CABINET

Monday 23 September 2019

SIZEWELL C STAGE 4 PUBLIC CONSULTATION RESPONSE

EXECUTIVE SUMMARY

Table 1: Comparison of mitigation measures of rail-led, integrated and road-led freightmanagement strategies (Table from the Stage 4 consultation document)

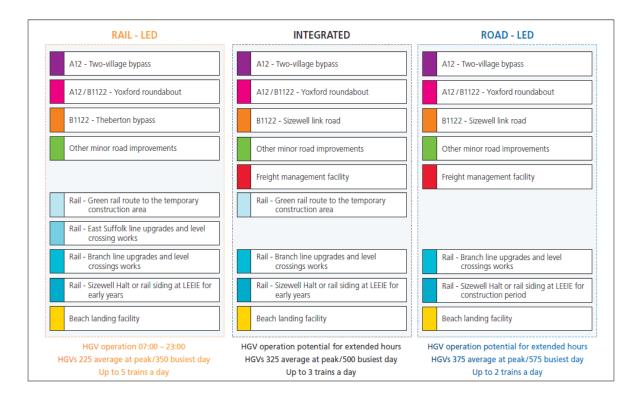
- 8.19 The integrated strategy would provide three rail deliveries (six rail movements) over a 24-hour period one more than the road-led option but two less than the rail-led option. It is important to note that of these six rail movements, five are during the night between the last and first passenger trains on the East Suffolk line, i.e. between 11pm and 6am. This is unlike the rail-led strategy where all rail deliveries are expected to occur during daytime (except for during the early years). The noise and vibration impact of these night-time movements on residents along the East Suffolk Line and Sizewell Branch line should not be underestimated. It should be noted that for the road-led and integrated options, trains would operate at a speed of 20mph, whereas with the rail improvements under the rail-led options, speeds could increase to 40mph. A rough calculation has identified at least 380 dwellings sited within 30 metres of the East Suffolk rail-line between Westerfield and the site.

- 8.20 Whilst the Councils wish to see a maximum amount of materials to be transported by rail to site, the Councils have concerns about the additional environmental impacts of the integrated strategy, with five night time trains running along the East Suffolk Line for a seven to ten year period following the 'Early Years' construction period. This would have associated impacts on communities, with significant numbers of residents living close to the rail line being affected in places including Ipswich, Woodbridge, and Saxmundham. EDF Energy has not included any mitigation proposals related to these impacts in its consultation documents and we are not convinced that there are appropriate mitigating measures that could address the impacts.
